ADDENDUM NO. 2

Date: January 26, 2010
To: Contractors
From: Brian Bales – Project Manager
Reference: Balcony Replacement – Oquirrh 5
Department of Corrections – Draper, Utah
DFCM Project No. 09058100
Subject: **Addendum No. 2**

Addendum No. 2

PROJECT: Oquirrh 5 Balcony Replacement
Draper, Utah
DFCM Project #09058100

A2
AE541
BALCONY DETAIL

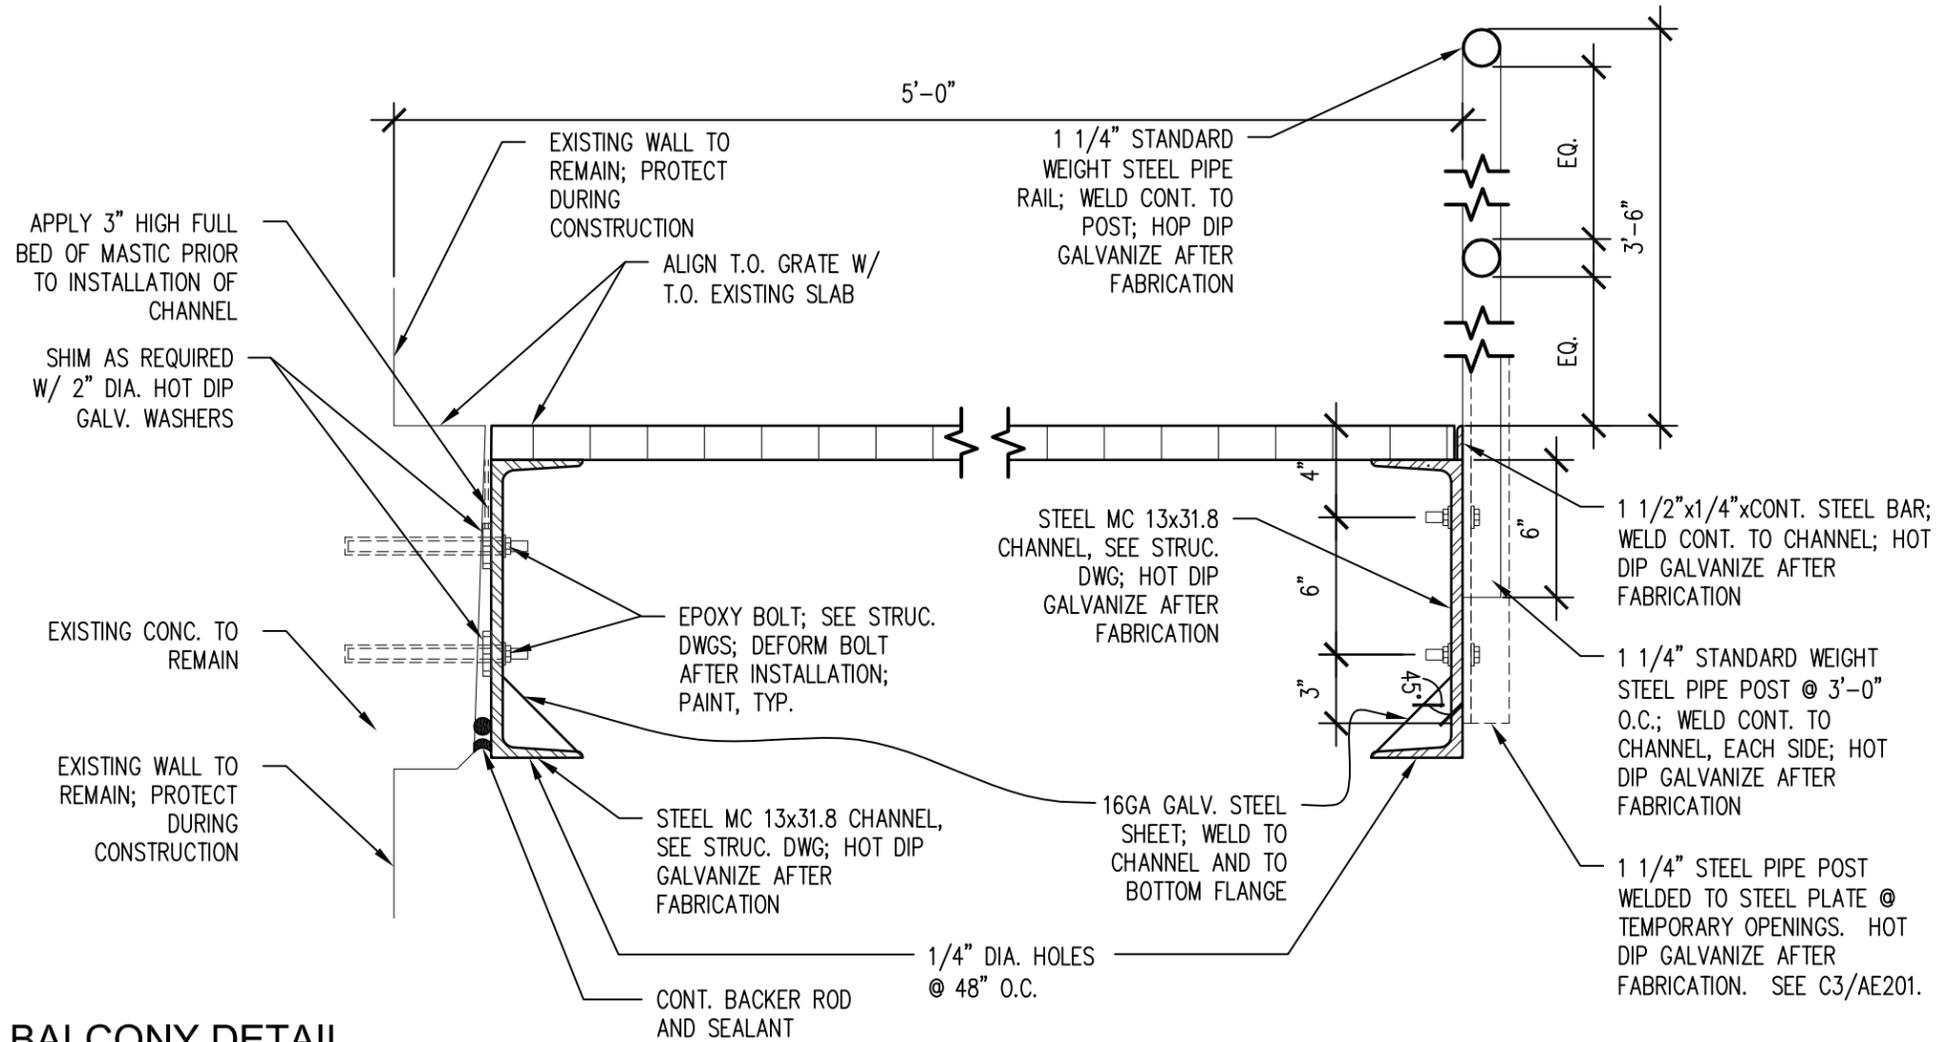
<u>Item No.</u>	<u>Section or Sheet No.</u>	<u>Description</u>
2-6	GI003	Add General Notes: "2. Temporary stairs shall be constructed of non-combustible materials" 3. Temporary safety barriers at balcony level shall be constructed of non-combustible materials; height to top of barrier to be 42" above walking surface. Barriers to be constructed to prevent passage of 21-inch diameter sphere from passing through barrier."
2-7	DP101	Change Key Note 1 to: "1. Existing steel column to be removed. Existing steel base plate and concrete footing to remain. Cut existing steel column flush with base plate and grind smooth."
2-8	AE541	A2/AE541; Replace detail A2/AE541 with attached detail A2/AE541.
